BAW-1543A, Rev. 2, Addendum 1
November 1987

**INTEGRATED REACTOR VESSEL MATERIAL
SURVEILLANCE PROGRAM
(Addendum)**

SUBJECT: REVIEW OF PROPOSED REVISION TO THE BABCOCK & WILCOX OWNERS' GROUP
INTEGRATED REACTOR VESSEL MATERIAL SURVEILLANCE PROGRAM.

This addendum to BAW-1543, Rev. 2, provides a revised insertion and withdrawal schedule for surveillance capsules in the Crystal River-3 and Davis-Besse reactors. Extensive changes are made in the irradiation schedule starting with the next refueling outages:

Figure 2-1. Crystal River-3 IRVSP Schedule

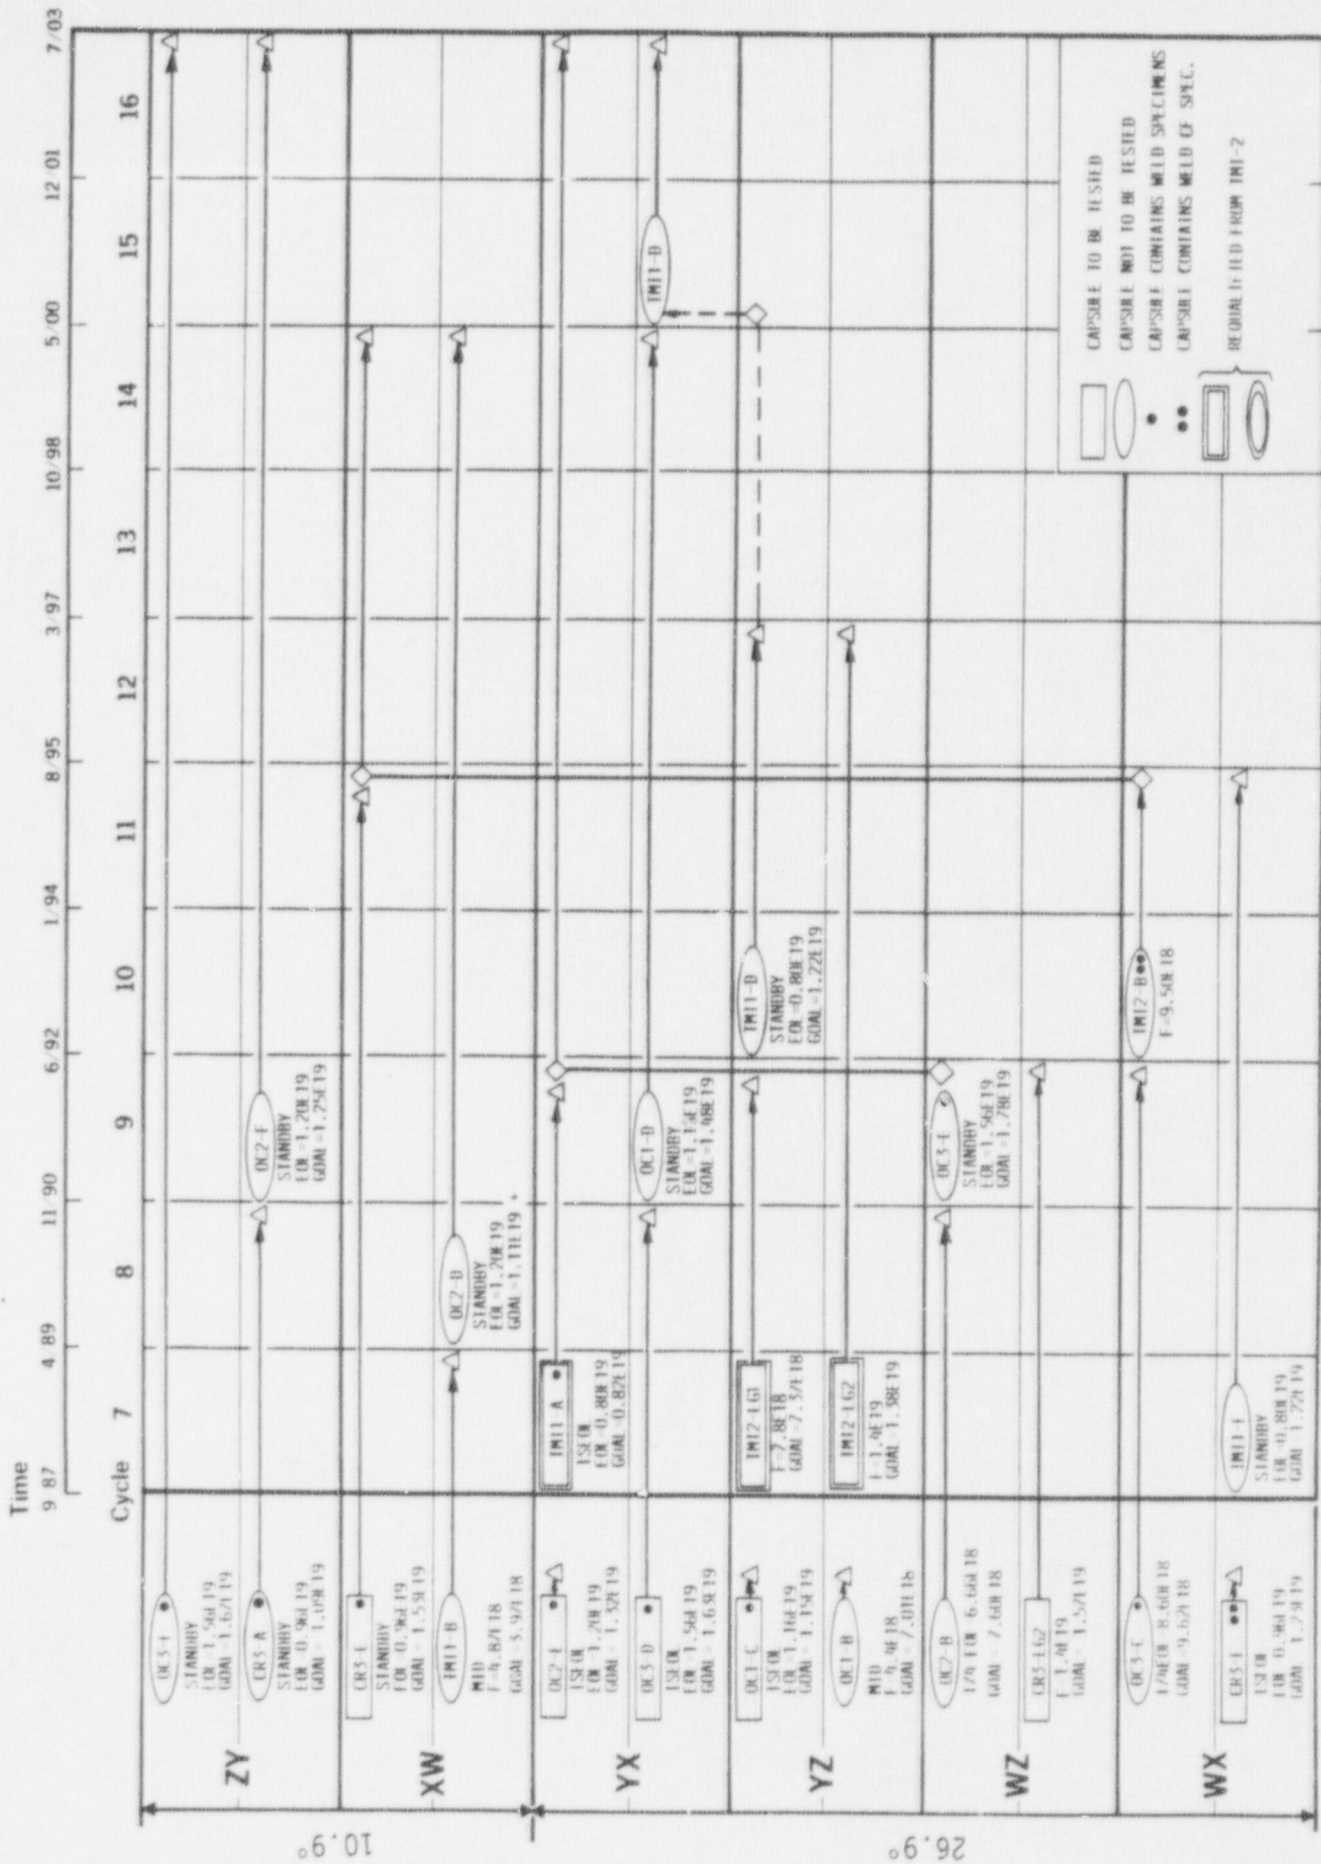
The revised insertion and withdrawal schedule for irradiation capsules in Crystal River-3 is presented in Table 2-1 and Figure 2-1. The revised insertion and withdrawal schedule for irradiation capsules in Davis-Besse is presented in Table 2-2 and Figure 2-2. A summary of the status of all irradiation capsules currently in the integrated reactor vessel surveillance program is presented in Table 2-3.

Thus, the capsules to be withdrawn and inserted during CR-3 cycle six outage are as per Table 2-1, page 2-2 of BAW-1543, Addendum 1, with the following exception. This removal of TMI1-A capsule from the schedule was included in the SER released by NRC. Capsule TMI1-A was opened to provide data to requalify the B&WOG research capsules for re-insertion. Thus a replacement capsule was needed to fill the remaining space in capsule holder YX TOP. Capsule TMI2-D was selected to be used as the filler or dummy capsule for insertion in YX TOP and is not considered to be a capsule needed for the Integrated Surveillance Program.
